GARDEN MEADOW ADDITION

WICHITA, SEDGWICK COUNTY, KANSAS

S/D 98-38 - Final Plat of GARDEN MEADOW ADDITION

CASE NUMBER: S/D 98-38 - GARDEN MEADOW ADDITION
(formerly HENDRICK'S GARDENS)

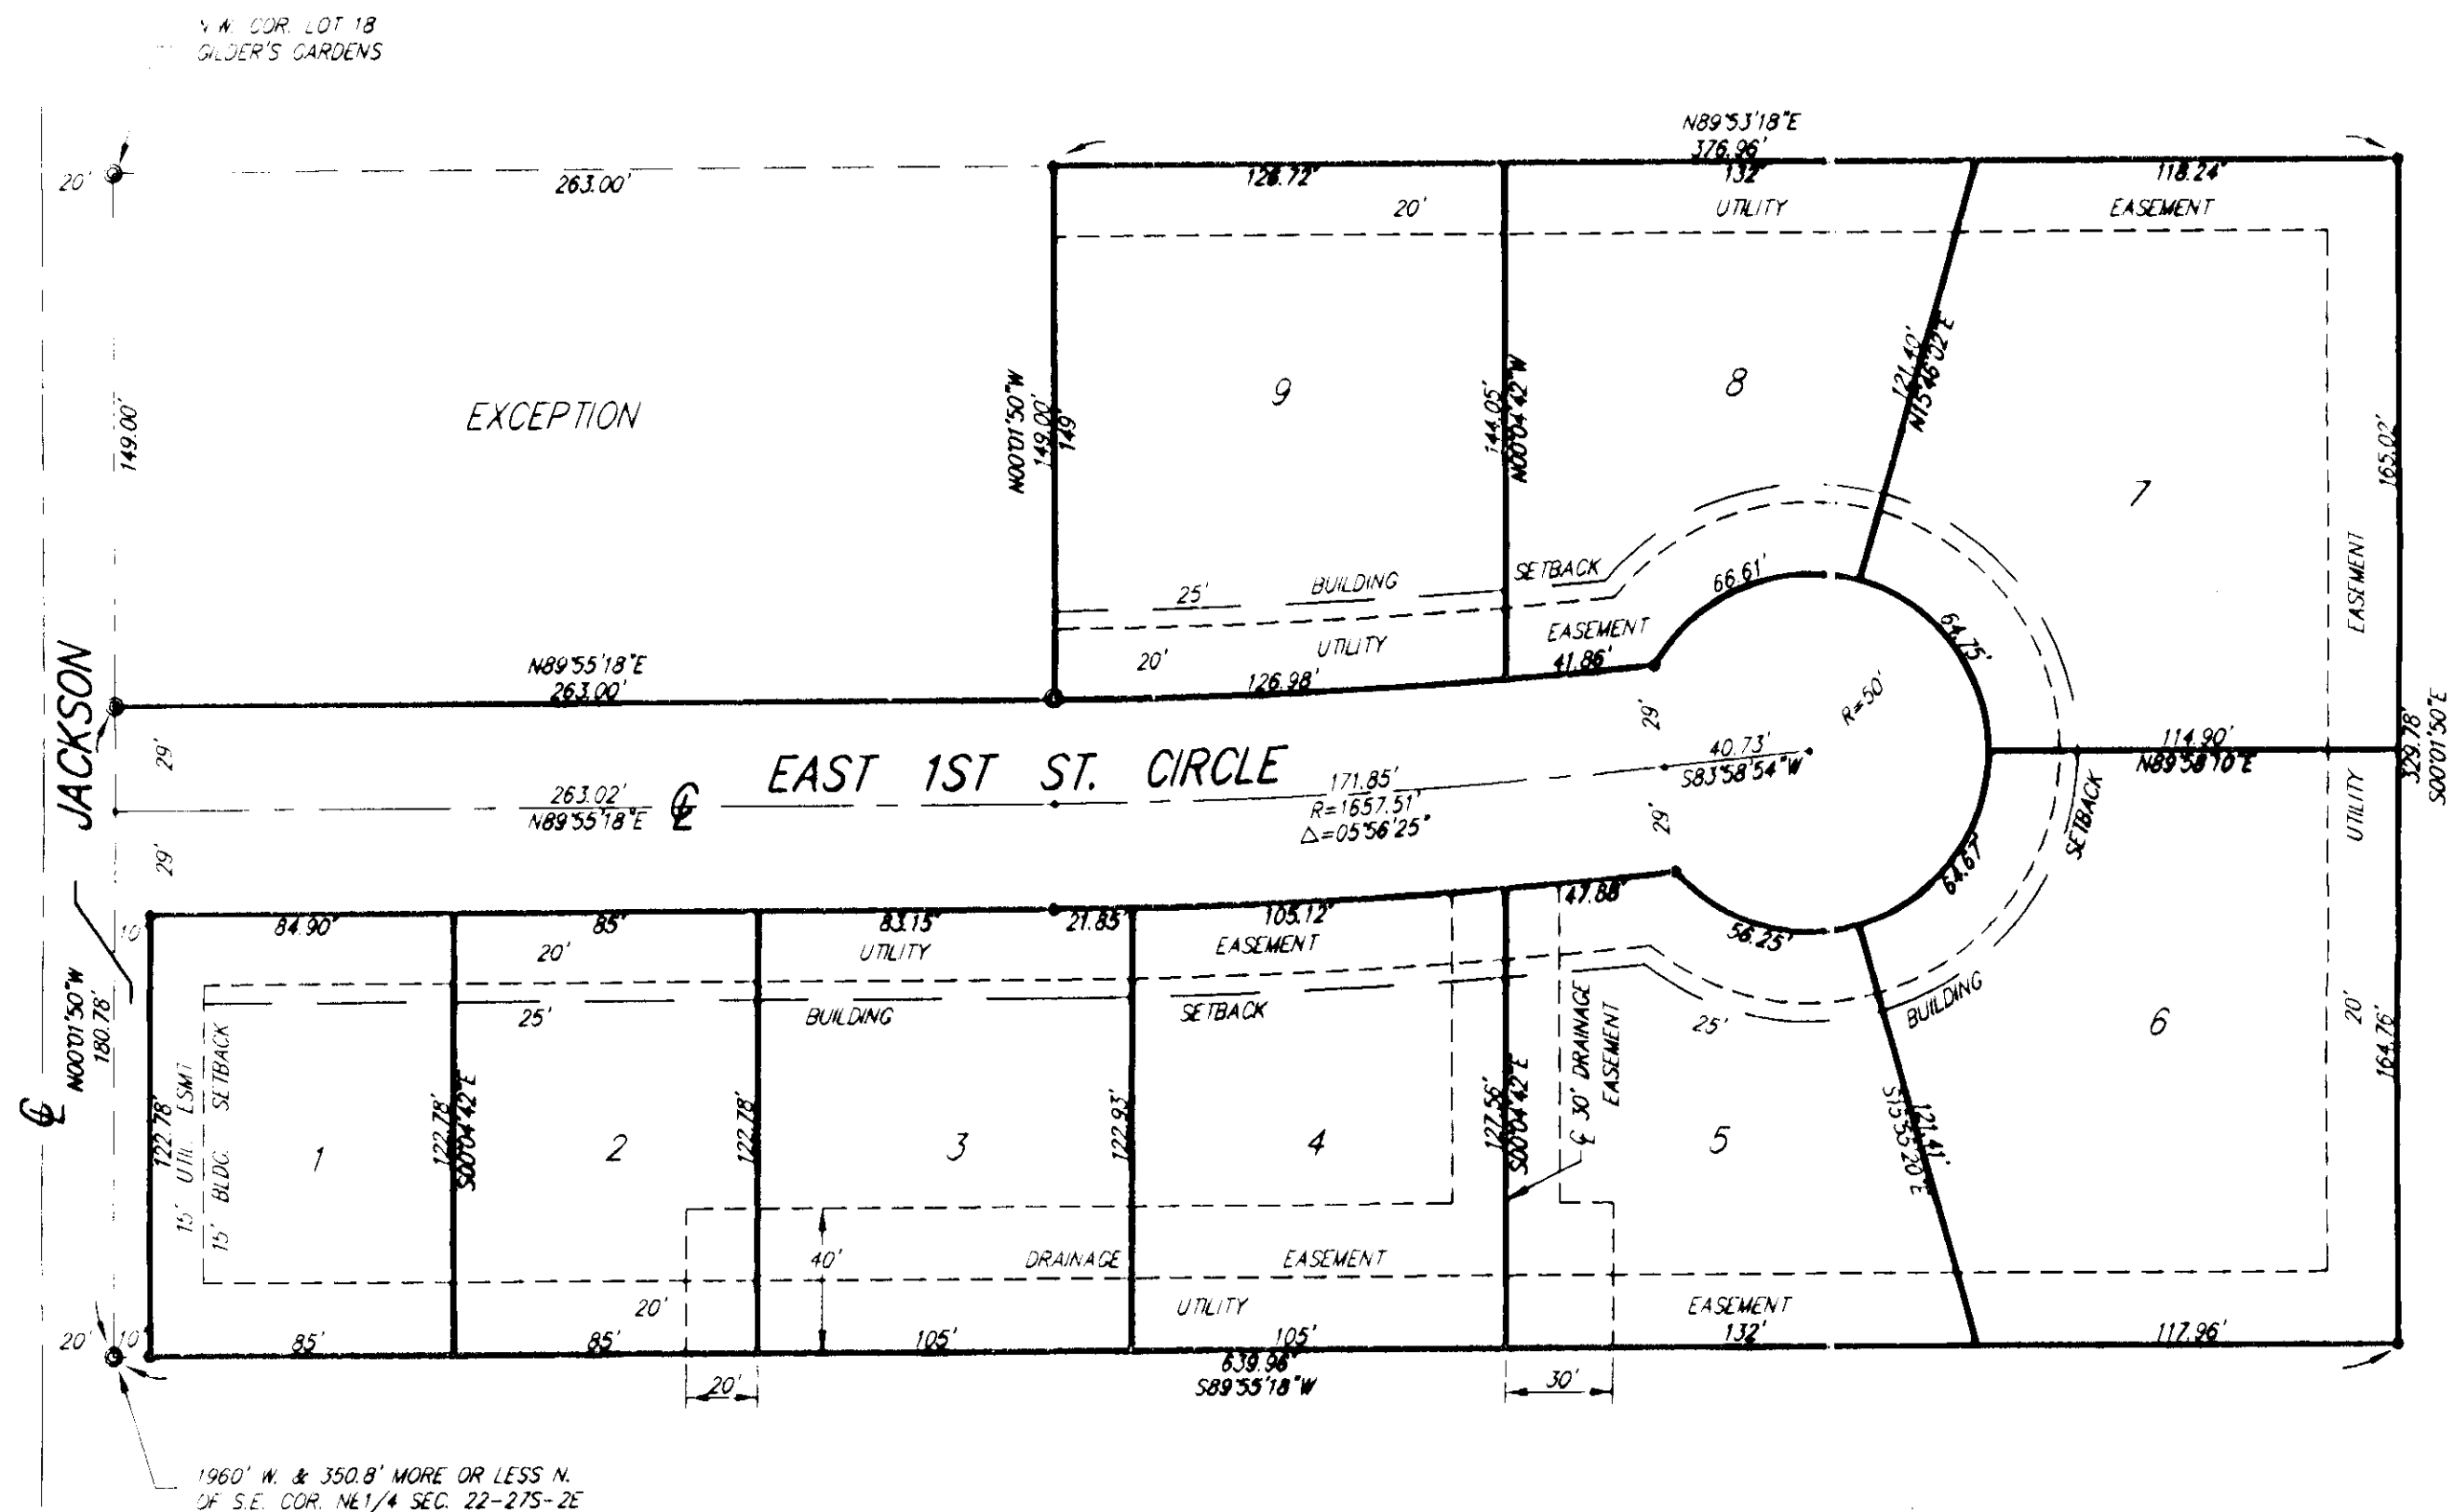
- A. City water appears to be available to this site. The applicant shall guarantee the extension of sanitary sewer to serve the lots being platted. This guarantee shall be with the County for service through the Four Mile Creek sanitary sewer system. On the final plat tracing, appropriate wording shall be added to the Mayor's signature block indicating the City's agreement to allow a County sewer district to be formed within the City. **A guarantee for City water will also be needed. A sanitary sewer layout is requested by County Engineering.**

- C. **City Engineering** needs to comment on the status of the applicant's drainage plan. **The drainage plan has been approved. An off-site drainage easement will be needed.**

- D. The applicant shall guarantee the paving of the proposed interior street.
- E. The applicant shall submit a covenant which provides for four (4) off-street parking spaces per dwelling unit on each lot which abuts a 58-foot street. The covenant shall inventory the affected lots by lot and block number and shall

- G. For any lots with existing tree rows that may be impacted by the installation of utilities, it is recommended that overly wide utility easements (30 foot) be platted in order to allow for the installation of the utilities without damage to such tree rows. Sanitary sewer and KG&E services are proposed to be constructed along front yard easements and applicant prefers to maintain 20-foot rear yard easement.

- H. Fire Department requests that the street be renamed "E. 1st St. Circle".
- I. On the final plat tracing, the spelling of "granted" in the owner's signature block needs to be corrected, in addition to "Hendrick".

- R. The representatives from the utility companies should be prepared to comment on the need for any additional utility easements to be platted on this property. **KG&E and Southwestern Bell request additional easements which have been denoted on the final plat.**
